Alert	
Product Bulletin # PHDC	-010
Serial #: All	Aug. 7, 2013
Model: PACE-X	Aug. 7, 2015

VFD Cabinet Access Must Be Limited to Qualified Personnel

DT22653			R, 1000V, /	Design Themas		•	-
REV B			х С		G	5

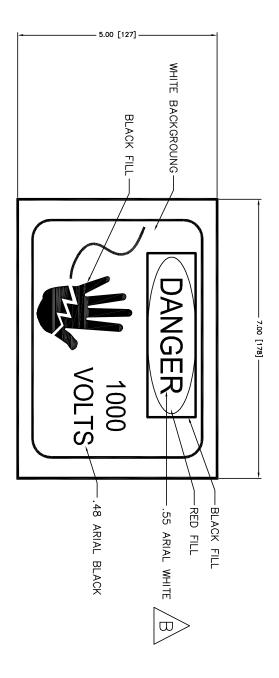
No.		80 _1					
Y/M/D		5/08/07					
ВY		RUC					
REVISION DESCRIPTION		15/08/07 TRU CHANGED FONT FROM RED TO WHITE					
CHKD.							
APVD.		_					
ARE RESERVED BY CANKIG WRILLING TECHNOLOGY LTD. (OF DESIGN AND INVENTION	PERMISSION AND RETURNED PON DEMAND. ALL RIGHTS	REPRODUCED WITHOUT		DRILLING TECHNOLOGY LTD.	THE PROPERTY AND	æ
CHKD. APVD. DRILLING TECHNOLOGY LTD. RADIUS UNLESS SHOWN = 0.03 MAX.	ACHINED SURFACES 2	TRUE POSITION .005	L SQUARENESS ± .010 IN 5 INCHES	OCONCENTRICTLY JUDS IN 5 INCHES OF STRAIGHTNESS + 005 IN 5 INCHES	STING ± 1/1	REMOVE SHARP CORNERS AND BURRS	TOLERANCE - UNLESS OTHERWISE SPECIFIED
ANGULAR MACHINING :		DECIMAL .x ± .030"	MACHINING IMPERIAL	280 & OVER ± 1/2"	3/16"	++/8	FABRICATING IMPERIAL (in)
Ϋ́	XXX + 13 mm FST WFIGH	DECIMAL ± .8 mm		MATERIAL	1525 TO 3048 ± 5 mm APPRV'D	U IU 610 E I mm CHECKED	DRAWN
			VINYAL		ESB	1	MXD
0				_	15/02/20		MXD 15/02/20
	PRO.IFCT		SIGN, DANGER,				THIRD ANGLE SHEET
